**Project #22-009
Foothill Residential Subdivision
Located at approx. 1250 N. 1300 E.**

REPORT SUMMARY...

Project Name: Foothill Residential Subdivision
Proponent/Owner: Rick Champlin / Foothill Lofts Residential LLC
Project Address: 1250 N. 1300 E.
Request: 25-lot subdivision
Current Zoning: NR-4
Date of Hearing: February 10, 2022
Type of Action: Quasi-Judicial
Submitted By: Russ Holley, Senior Planner

Figure 1 shows all four proposals. Top left PC 20-011, Top right PC 20-052, bottom left PC 20-059, bottom right PC 22-009

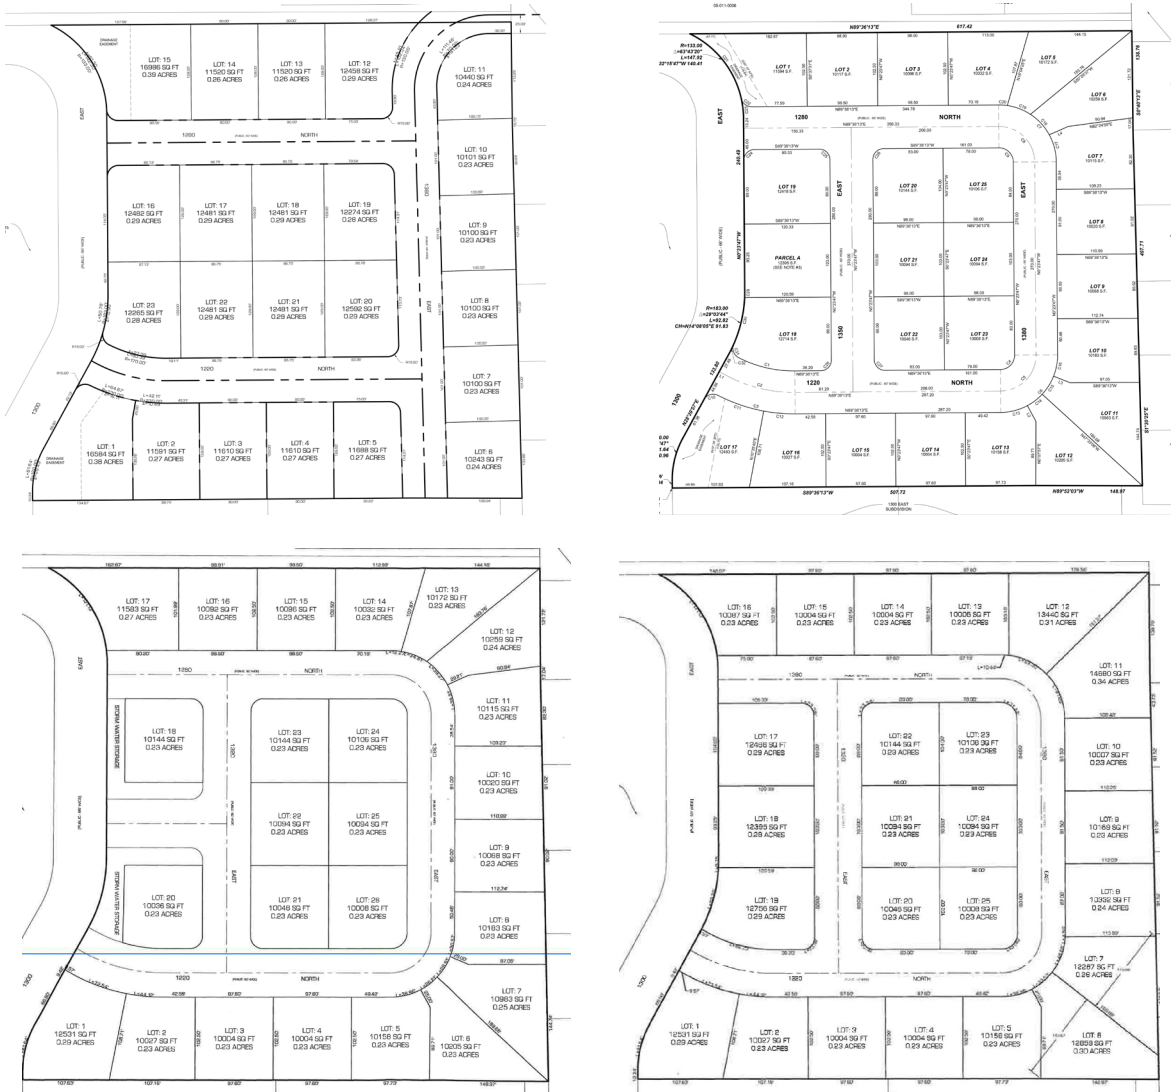
This is the fourth subdivision proposal from this owner for this property in the last two years. First, in August of 2020 (PC #20-011), a 23-lot subdivision was proposed with a northeast street stub with the potential of connecting to 1400 East. After debating neighborhood issues, the proposal was denied by the Planning Commission. Second, in October of 2020 (PC #20-052), a 25-lot subdivision was proposed showing no street stubs to the east and only two street connections onto 1300 East. After debating street connectivity standards, the Planning Commission also denied that application. Thirdly, in December of 2020 (PC-#20-059), a 25-lot subdivision was submitted showing three street connections onto 1300 East. The Planning Commission approved this application. In December of 2021, PC #20-059 expired since the final plat had not been approved and recorded.

Figure 4 shows the surrounding areas.

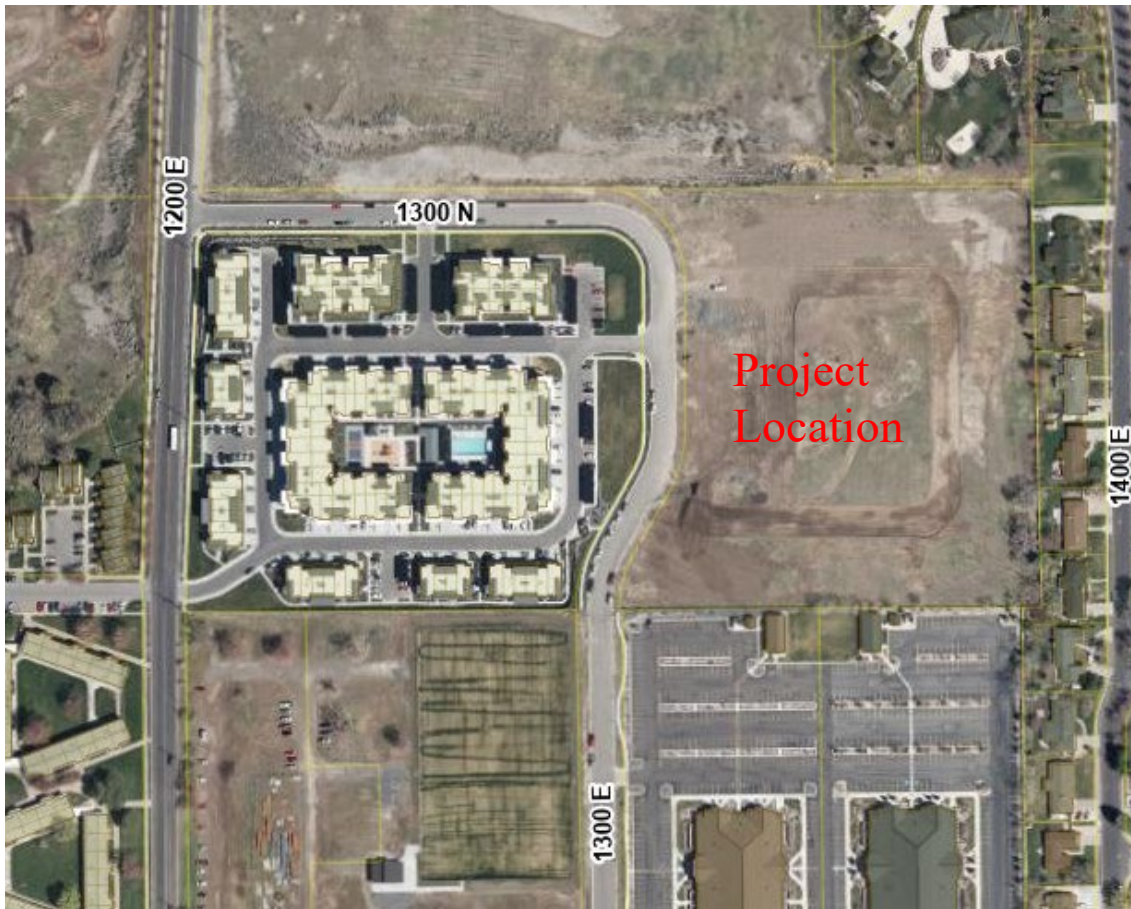
The proposed 60' wide street rights-of-way meet the recently adopted Logan City Standards and Specifications. The LDC requires 3 points of connection for subdivisions greater than 20 lots in typical situations. LDC 17.30.070 outlines standards for block layout, street stubbing and neighborhood connectivity. The subdivision proposes 2 points of connection onto 1300 East. The other three sides of this development contain existing development or steep topography creating barriers for street connection possibilities to the north, east and south.

The applicant is requesting a deviation from the street connections standards due to the constraints associated with this project site. The applicant considers two street connections appropriate in this situation considering the surrounding development and steep slopes. As per LDC, the Planning Commission may, upon substantiating findings, approve alternatives to the street connection standards when there are no practical design alternatives for compliance. As conditioned, with the Planning Commission determining the street grid connectivity, the subdivision meets the requirements in the LDC.
